Planning & Zoning Board

Thursday, June 1, 2023

**MINUTES Regular Meeting
REYNOLDSBURG Planning & Zoning Board
May 18, 2023**

PRELIMINARY
SITE PLAN

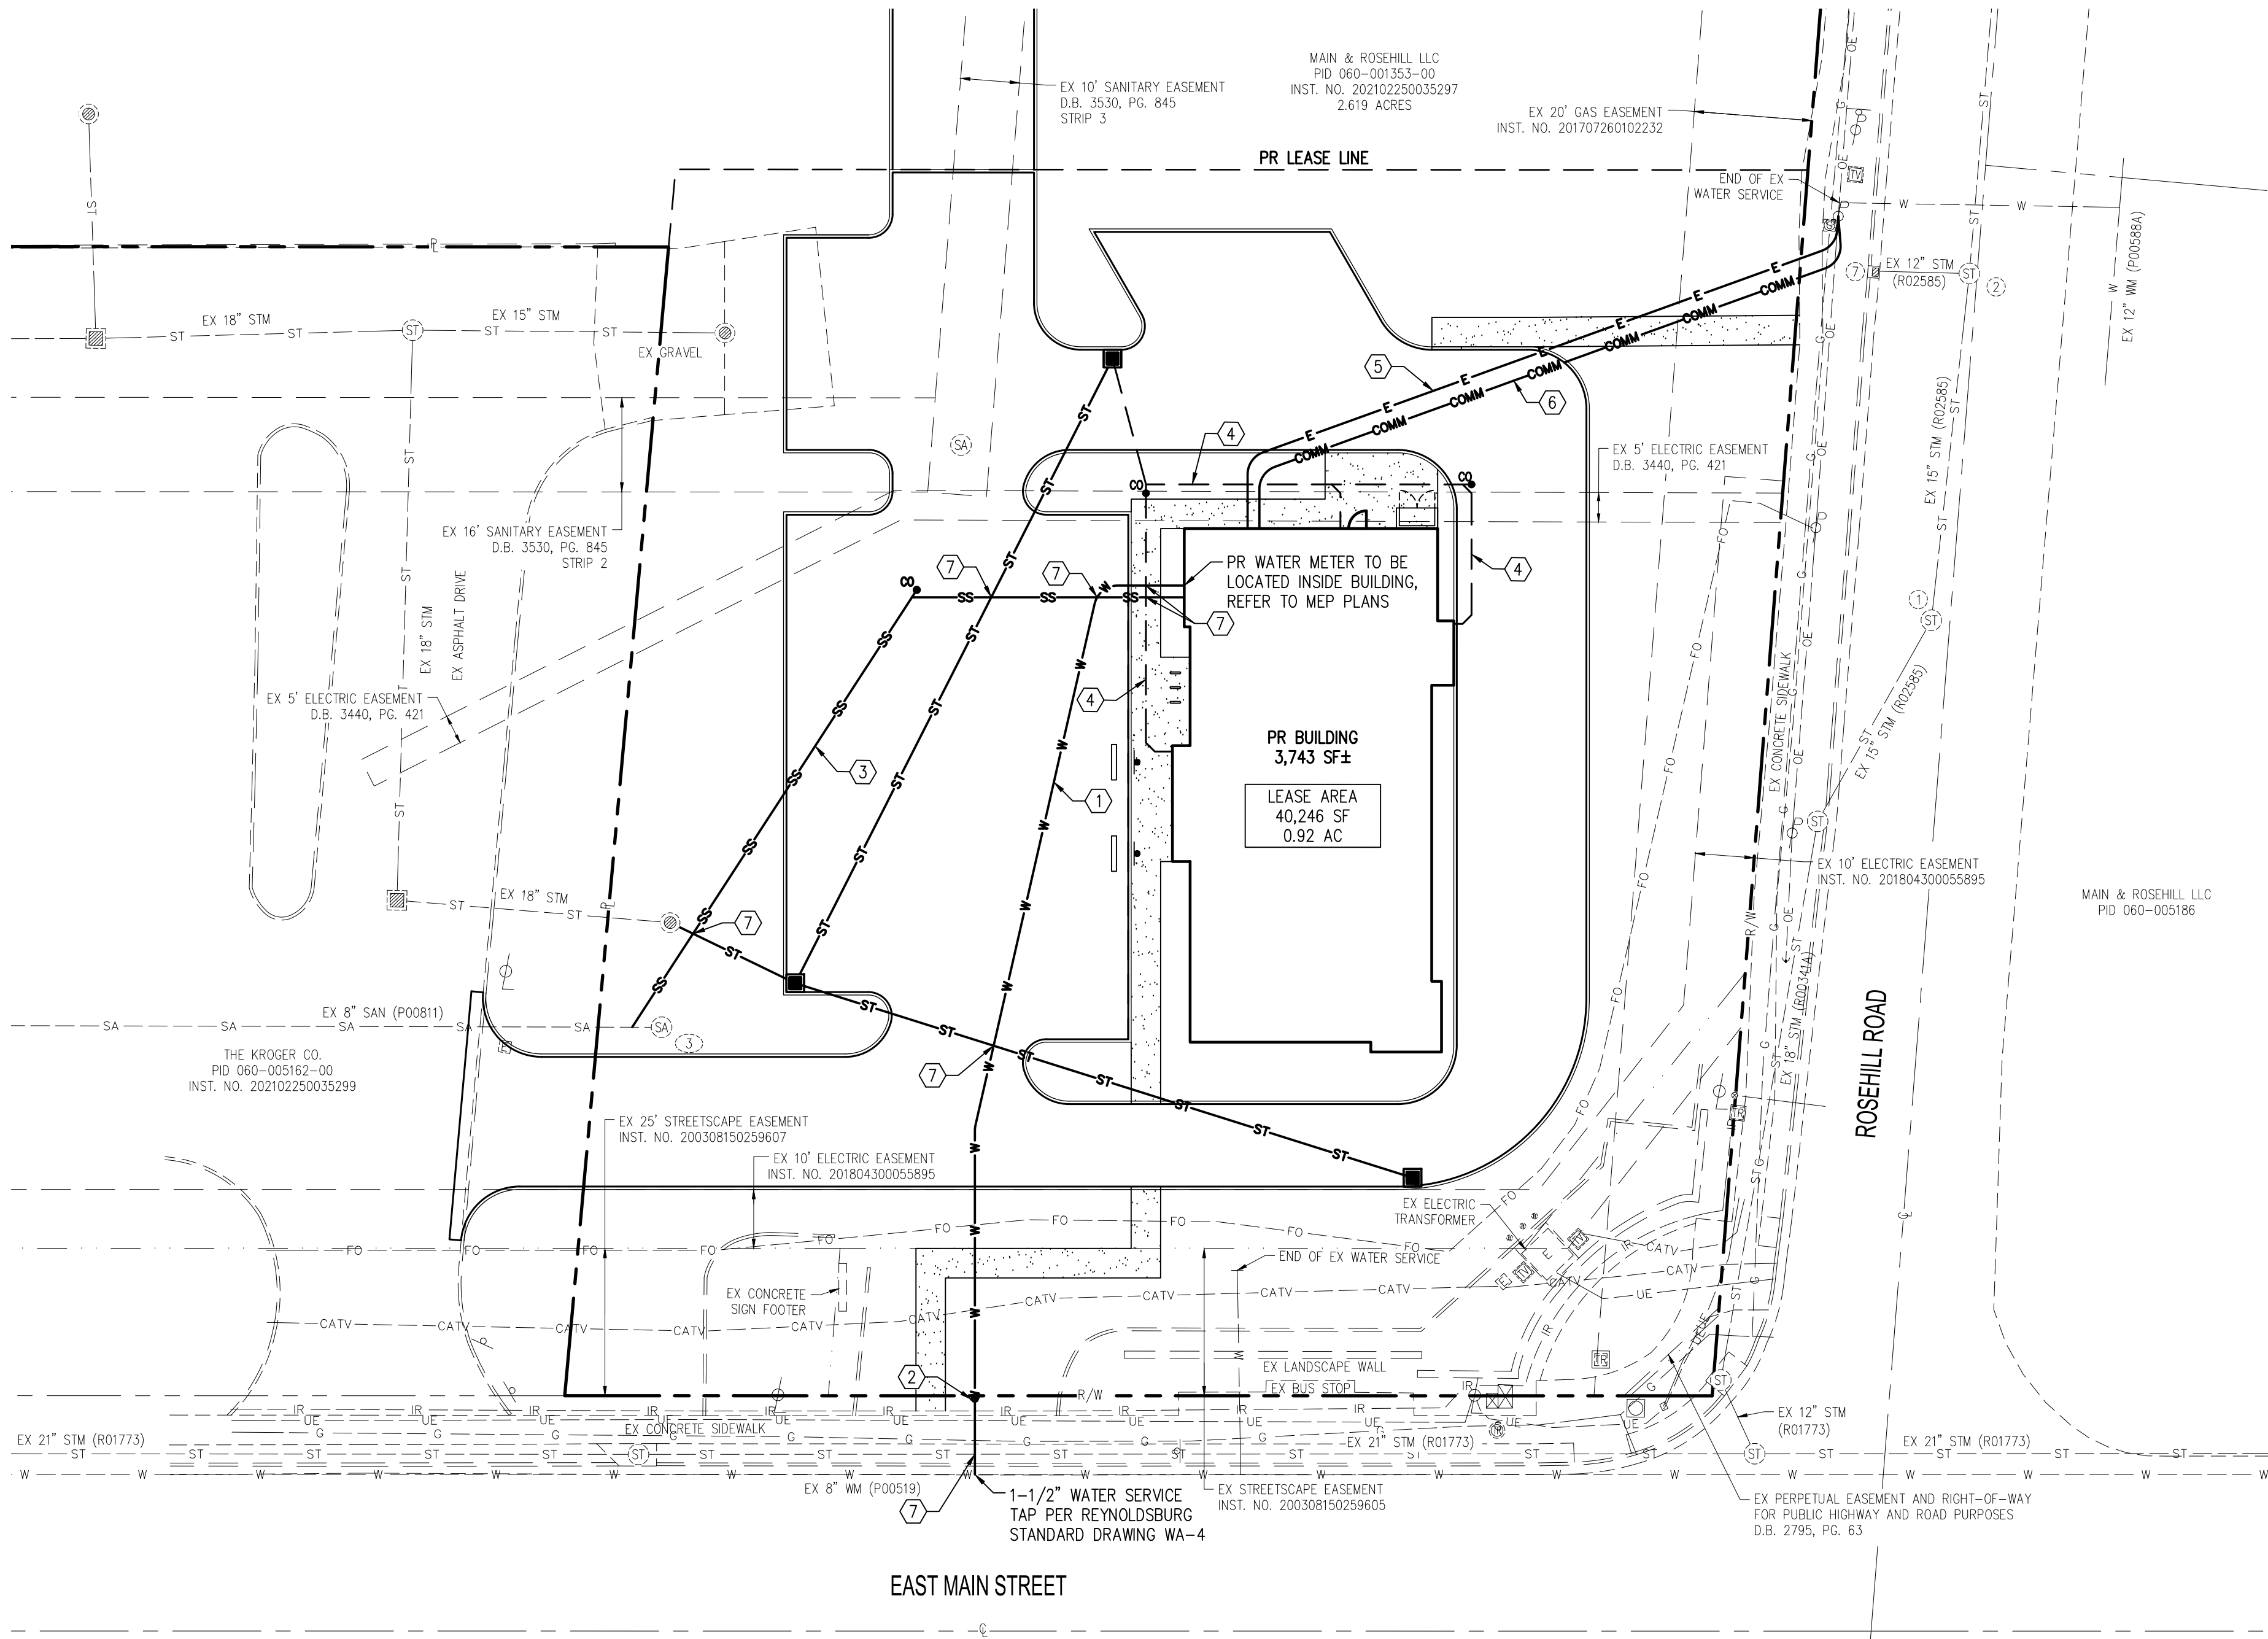
- b. The north access point is shown as 24-feet wide and is adequate.
 - c. Note that the north access drive is shown as "by others". This will need to be discussed during further development review such as Major Site Plan (if applicable).

- a. A by-pass lane is shown, and has been extended from the previous submission to provide a greater available distance for vehicles to "escape" if they mistakenly travel into the ATM queue. The by-pass lane now extends the entire length of the ATM queue on the east side of the building and is adequate given the number of expected vehicles that will queue based on the study provided.

5. The site plan shows pedestrian connectivity to the right-of-way via two separate sidewalks exiting the facility and connecting to existing walks on both East Main Street and Rosehill Road.

7. A loading space is not included in the site plan. A variance has been requested to allow the site to not include the loading space. Based on the information provided regarding operations and delivery procedures, EMH&T supports this variance request.

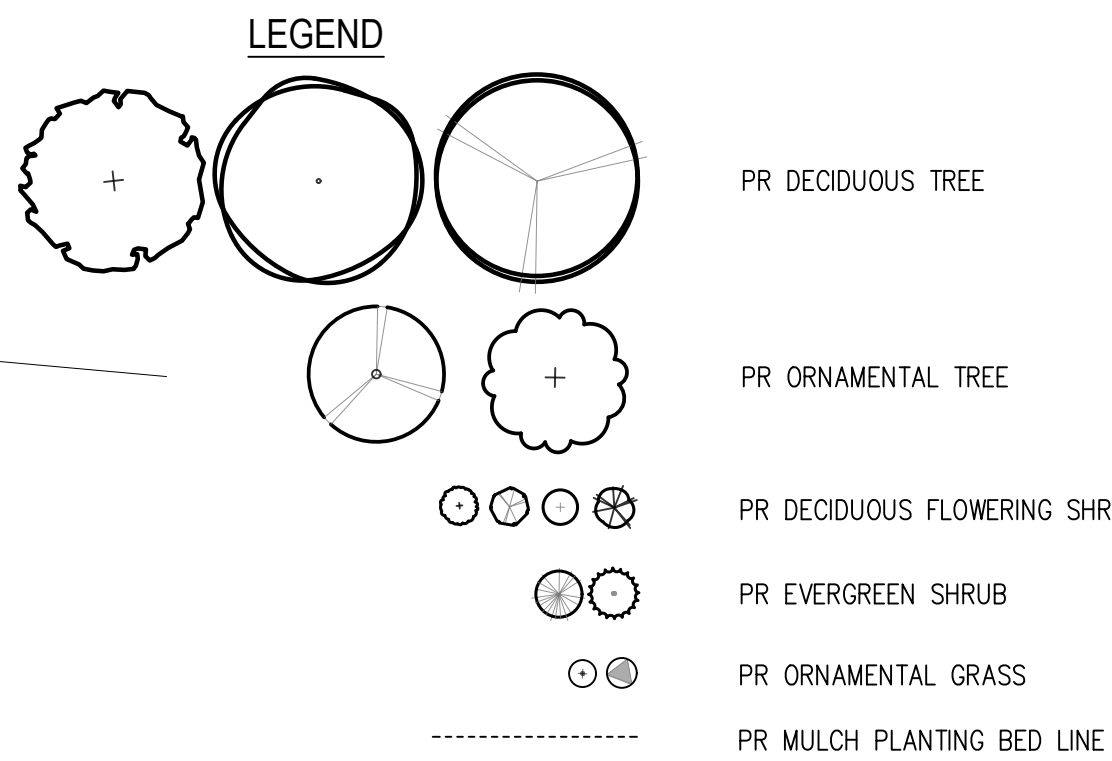
8. The project proposes to tap into the existing 8-inch watermain located on the north side of East Main Street via a 1.5-inch water service line extended into the site with the water meter to be located inside of the building.
9. As shown, sanitary sewer service will be provided via a proposed lateral extended into the site from an existing 8-inch line on the north side of East Main Street. The existing sewer connection point will need to be further investigated through record plans and other available information. Currently, there appears to be conflicting information. This can be determined during further development submittals, i.e. Major Site Plan, or at PGU.
10. There is no site lighting currently shown.

11. The utility plan shows a series of catch basins in the parking and drive areas. The storm sewer is shown outletting into existing storm sewer to the west at the fueling station. Based on the Kroger plans, this appears to be the correct location as the existing underground detention system appears to have been sized to include this outlot. This will need to further investigated and confirmed with PGU.

12. Verify with the Fire Department if a fire department connection will be required.
13. Where applicable, refer to Reynoldsburg Standard Construction Drawings.
